LR-N95220

**PERMANENT HYDROGEN WATER CHEMISTRY SYSTEM
HOPE CREEK GENERATING STATION
FACILITY OPERATING LICENSE NO. NPF-57
DOCKET NO. 50-354**

HYDROGEN TUBE TRAILER ANCHORAGE

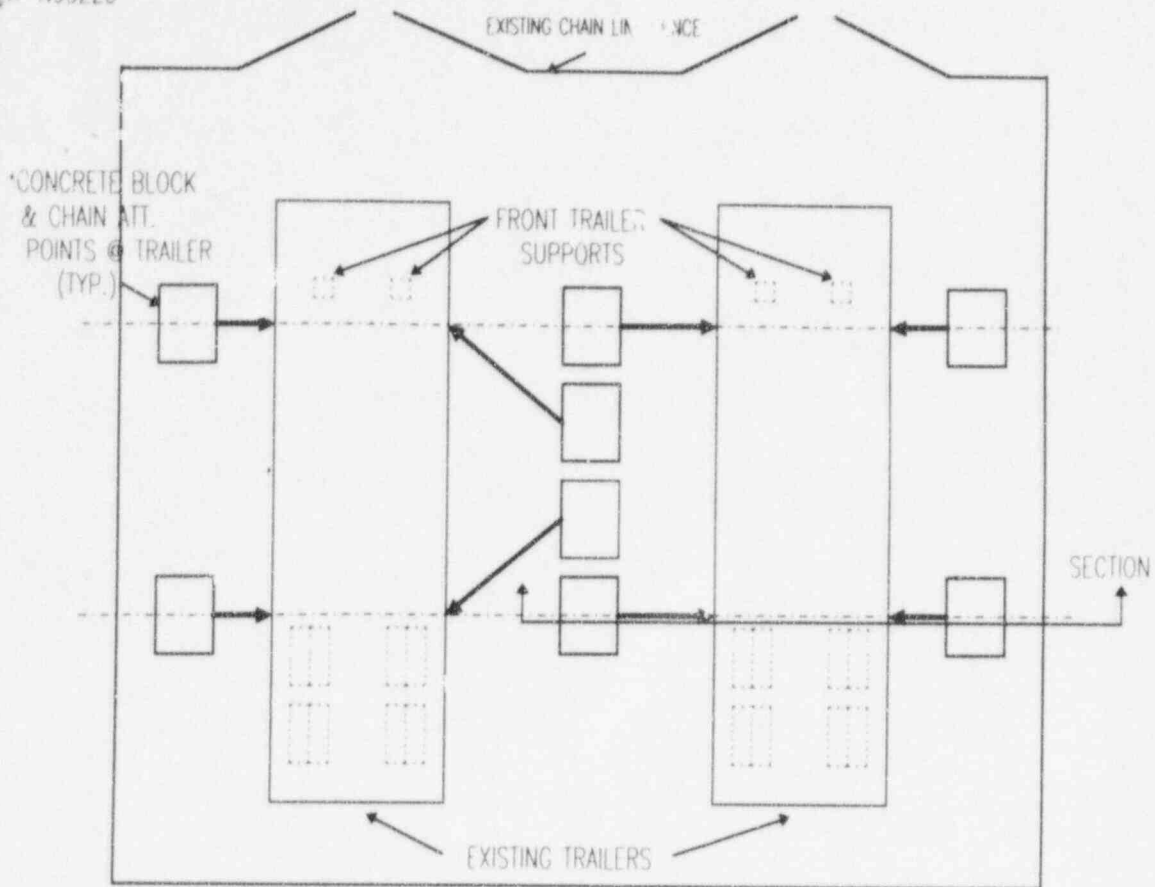
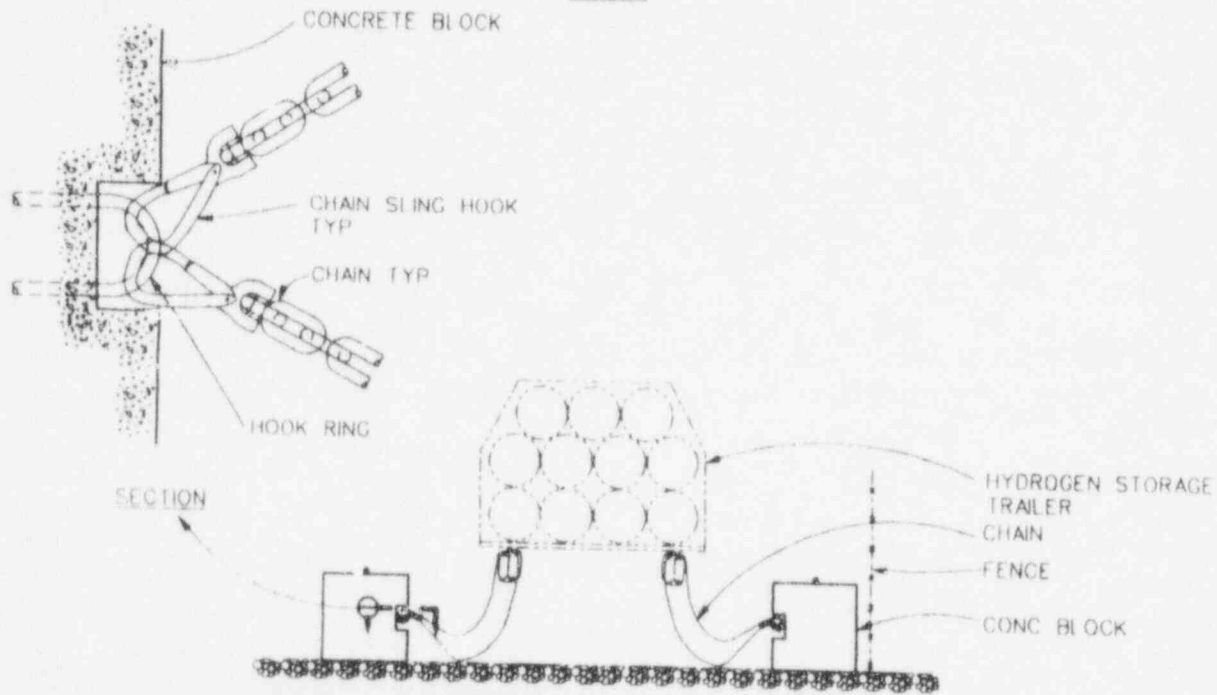
PSE&G plans to restrain each hydrogen tube trailer with four (4) approximately 4 ton concrete blocks as shown on the attached Figure. Each block will be connected to the adjacent trailer with a removable chain. The chains and concrete block connections will be designed with sufficient margin to ensure the blocks will remain attached to the trailers during a design basis

tornado. The proposed anchoring will provide the necessary restraint to decrease the maximum calculated travel distance of a hydrogen tube trailer with one tube attached that may result from a design basis tornado by approximately 50%. Therefore, the proposed anchoring will address the possible uncertainties in the methodology used to calculate transport distances by providing effective restraint of the trailers, and provide further assurance that the safe separation distance required in accordance with EPRI Special Report NP-5283-SR-A will be maintained.
